NEBRASKA CAPITOL ENVIRONS COMMISSION STAFF REPORT

APPLICATION NUMBER	Urban Design Record #24087
APPLICATION TYPE	Certificate of Appropriateness
ADDRESS/LOCATION	802 J Street
HEARING DATE	July 12, 2024
ADDITIONAL MEETINGS	June 28, 2024
APPLICANT	Wynn Hjermstad (Urban Development), whjermstad@lincoln.ne.gov
STAFF CONTACT	Collin Christopher, 402-441-6370, cchristopher@lincoln.ne.gov

Summary of Request

ATTACHMENT B – Site Plan

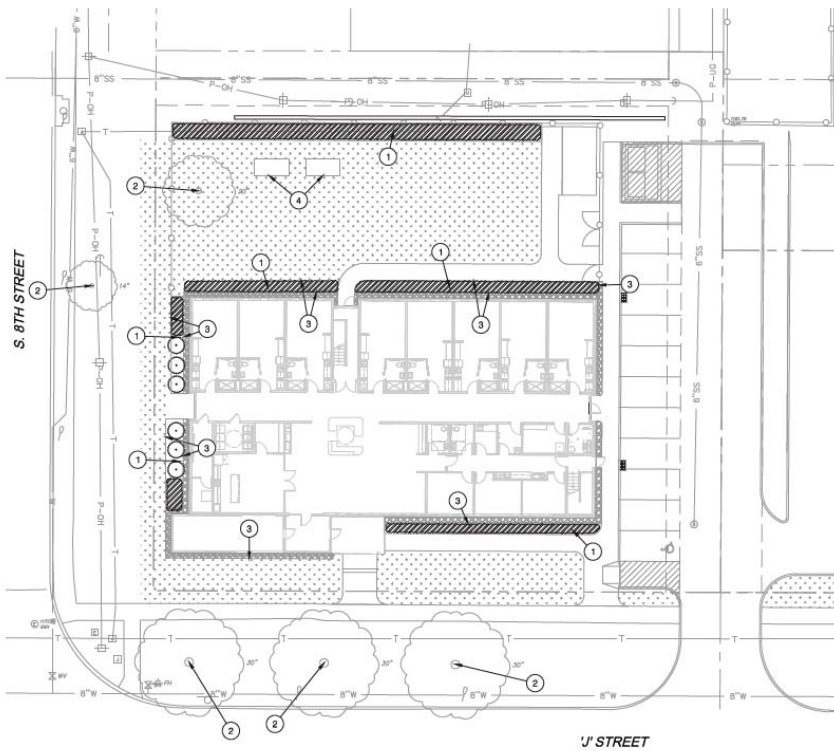
The setback of the building, particularly along the J Street side, is greater than what is typically expected in the district. Given the residential nature of the project and the particular design features of the south façade with a protected patio space, the desire to set the building back is understandable. Regardless, it still deviates moderately from the intent of the standards.

Compatibility per Staff Analysis: This section of the standards is much more explicit in its desire to see new buildings built to the property line along J Street. The proposal clearly deviates from this expectation.

Beyond that issue, it should be noted that the landscape plan for the project is still conceptual and lacking in details that might be of interest to the Commission like proposed plant species. If the Commission is interested in approving a more developed landscape plan at a future meeting, that direction should be provided to the applicant.

1. The Commission could approve a Certificate of Appropriateness for the project as proposed, understanding that it deviates from the standards. Approving such a deviation is within the purview of the Commission.
2. The Commission could defer a decision to the July meeting to give the applicant a chance to modify their proposal to meet the expectations of the design standards as written.
